To: Missoula City Council, Mary McCrea (City Development Services) cc. Burley McWilliams From: Teresa Jacobs, Wapikiya neighborhood resident

Pedestrian routes, bus stops, and traffic flow/safety are still on my mind in regards to the proposed Hillview Crossing development. I hope that you will require Hillview Crossing to align with the city's commitments (green and clean) to help residents access buses and otherwise move safety around the city on bikes and on foot, while also not creating hazards for buses and other vehicles. I hope you will consider inviting MCPS's Operations Director Burley McWilliams and others (Beach Transportation that serves MCPS and Mountain Line) to help sort out some possible ramifications of current plans and what might be other better alternatives.

Photo:

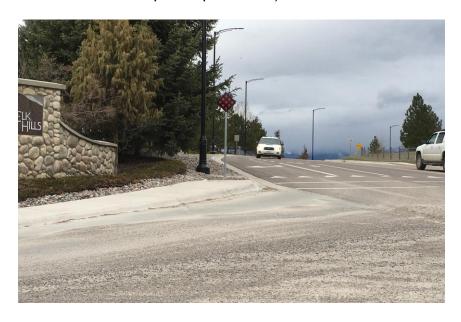
See right turn lane off Hillvew Way at the entrance to Elk Hills development (at Hilliview and Clearview) that keeps uphill traffic from being impeded. Also note the sidewalk there on a relatively flat stretch of road.
